**JAGUAR LAND ROVER, HALEWOOD
BODY IN WHITE SOUTH EXTENSION**

**DRAINAGE TECHNICAL NOTE IN REPOSE TO LLFA
COMMENTS FOR PLANNING REF:22/00458/FUL**

Report Title: Drainage Technical Note in Response to LLFA Comments for Planning Ref: 22/00458/FUL

Report Reference: JLR-RDG-00-ZZ-RP-C-0001

TITLE:
EXISTING DRAINAGE AND
PROPOSED ABANDONMENT PLAN

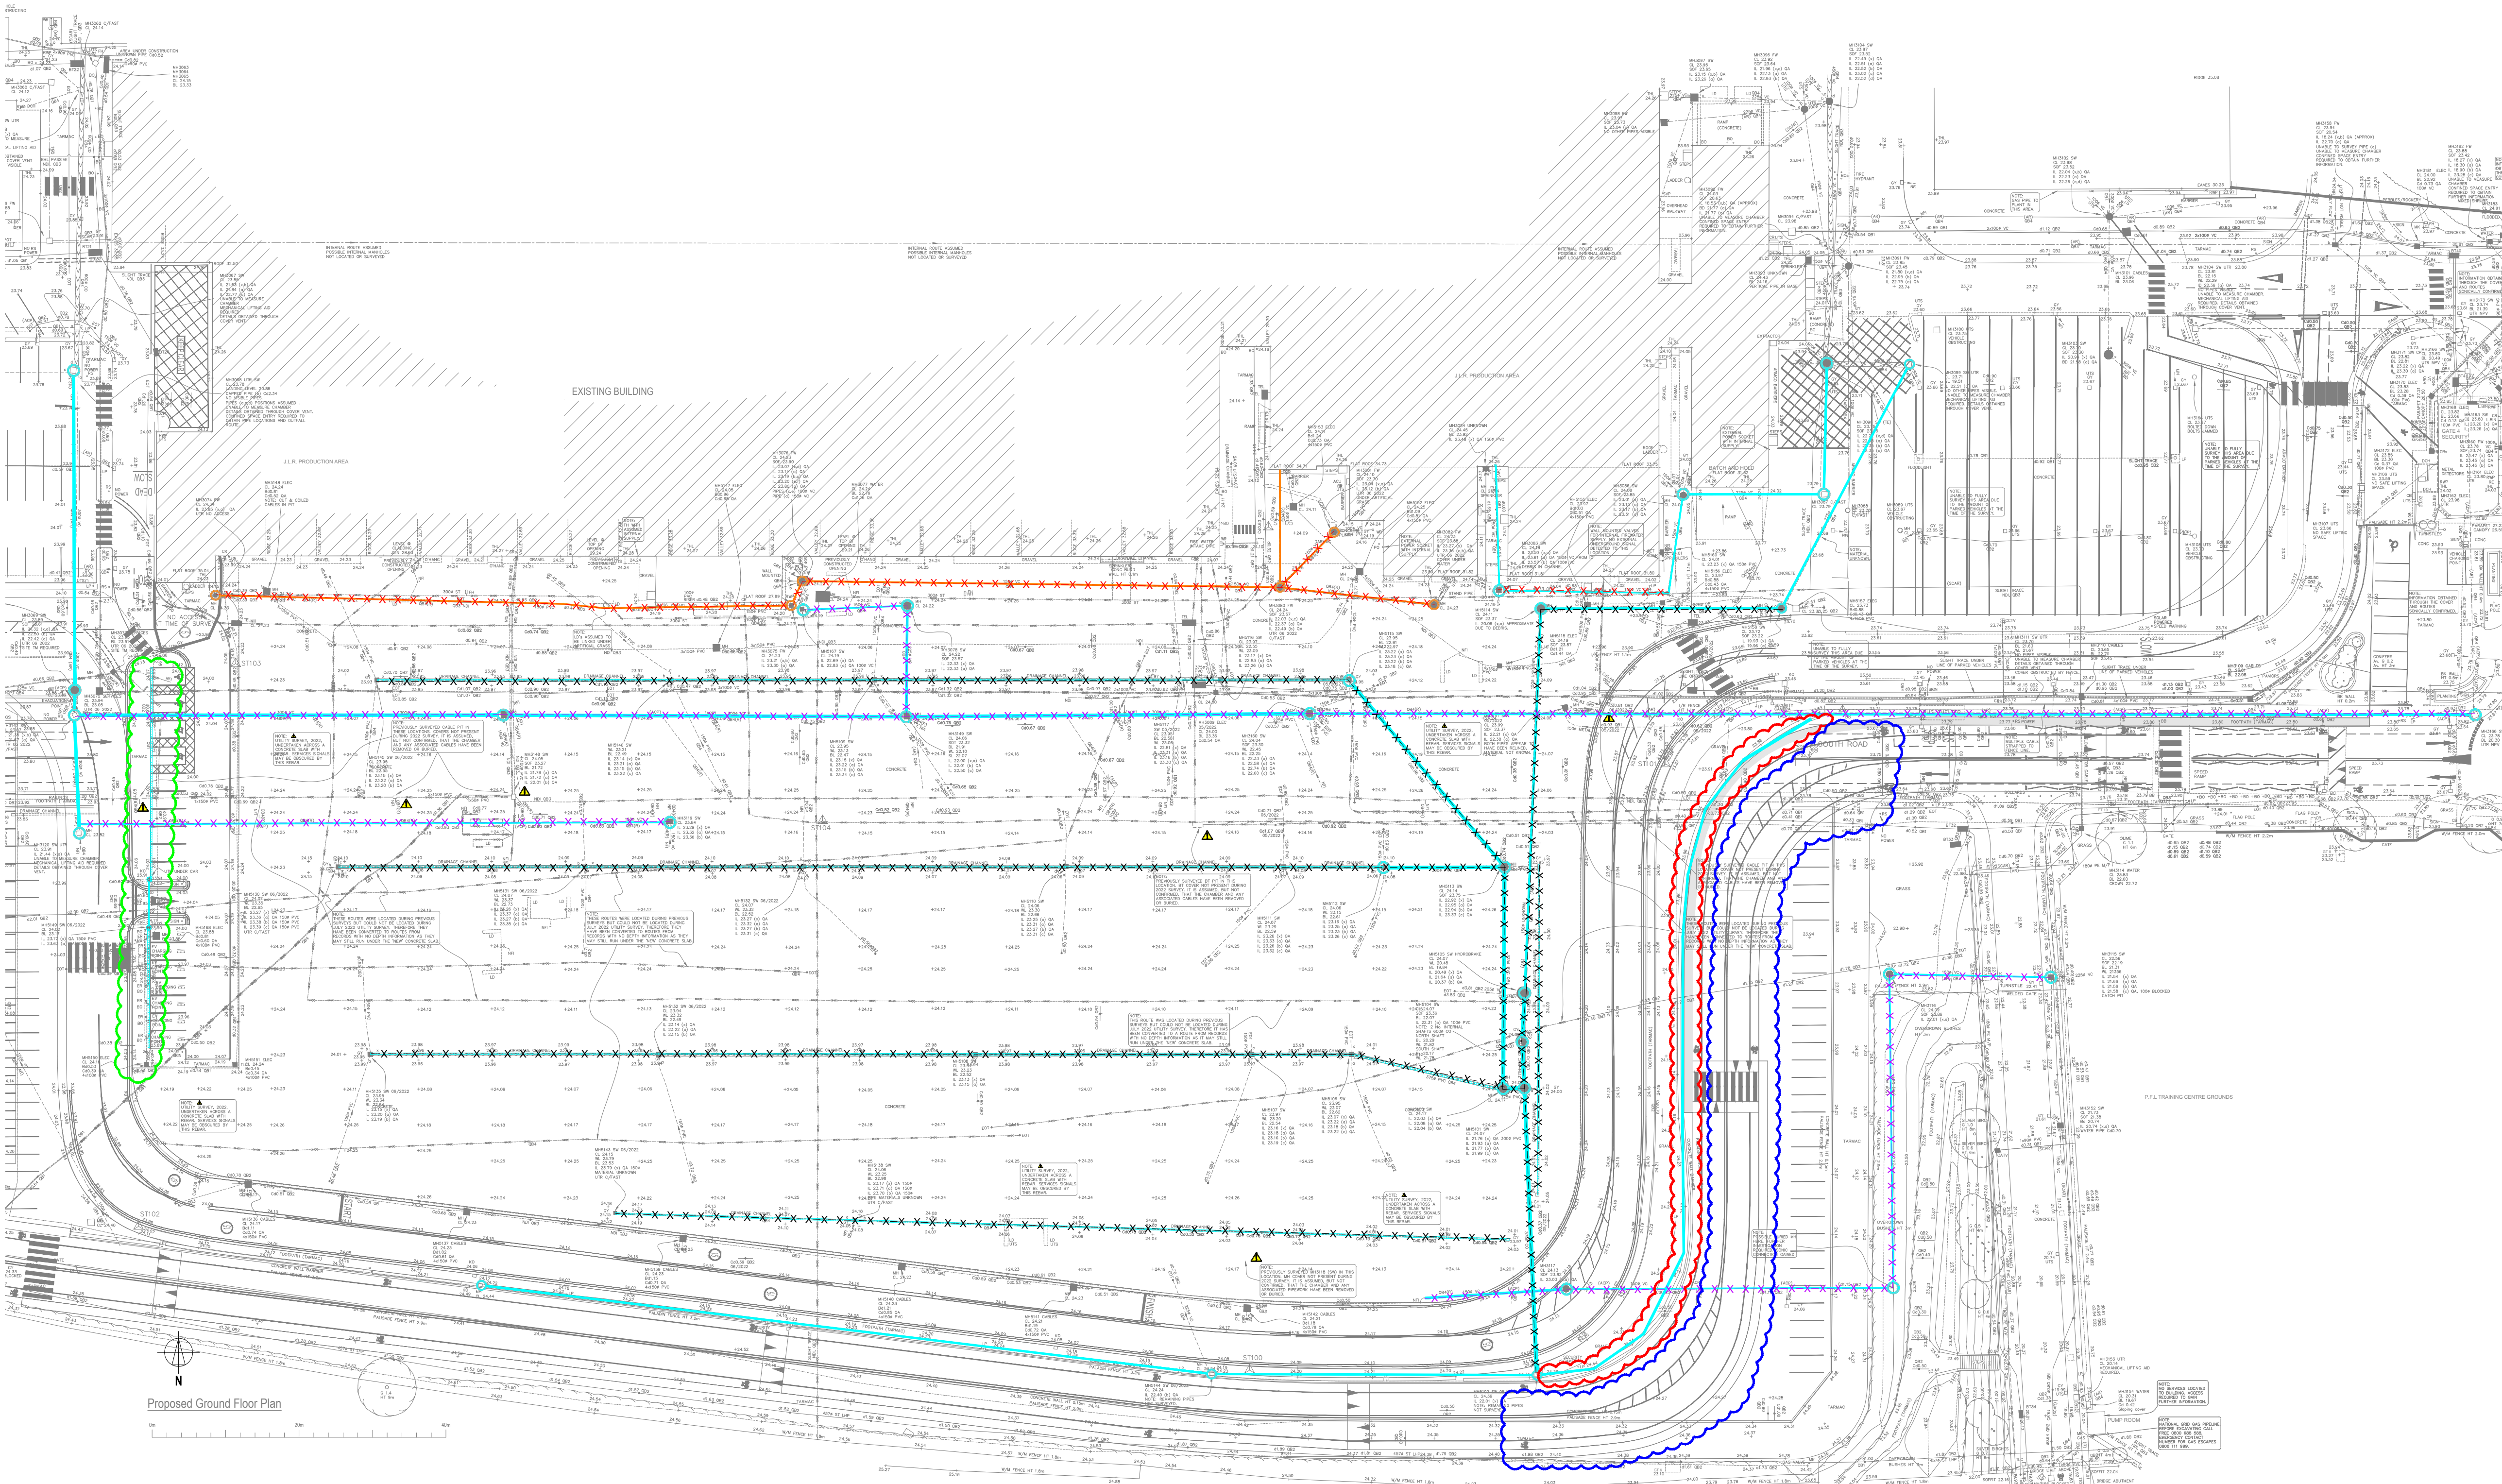
LLFA Comments	Ridge Response
The existing drainage system has been surveyed but no explanation of its features, outfall(s) and how surface water is being managed have been provided. It would be required to demonstrate that which part of the existing drainage system (including network pipes and outfall(s)) will be remained, diverted, or demolished.	Additional plan has now been provided to show the existing private surface water drains and existing private foul water drains. The Existing Drainage and Proposed Abandonment plan and the Proposed Drainage GA plans have been included within Appendix A. Proposed Abandonment plan highlights the existing private SW drains that are to be abandoned as they are not in operation and are not taking any flows. The Proposed Drainage GA plan highlights the proposed diversion of the existing drains. These diversions are essential as parts of the existing drainage system are located underneath the proposed building footprint. It is not feasible to keep the existing drains in place due to possible damage from the proposed building foundations.

ADDITIONAL TOPOGRAPHICAL SURVEY REQUIRED FOR THE EXTERNAL HIGHWAY AND POSSIBLE BELOW GROUND SERVICES. THIS AREA IS NOT CURRENTLY PICKED UP ON THE CURRENT TOPOGRAPHICAL SURVEY. THIS INFORMATION IS TO HELP CONFIRM THE SW TANK LOCATION AND ANY OTHER SERVICES.

POSSIBLE SW DRAIN ROUTE, HIGHLIGHTED ON JLR DRAWING REF : EMA1003A PRIVATE DRAIN HIGHLIGHTED REQUIRES A DRAINAGE SURVEY TO CONFIRM THE DRAIN ROUTE, INVERT LEVELS, ITS OUTFALL AND ANY INCOMING CONNECTIONS

EXISTING SW DRAIN REQUIRES A DRAINAGE SURVEY TO CONFIRM ITS OUTFALL AND EXISTING DRAINAGE INFORMATION (LEVELS, PIPE SIZE)
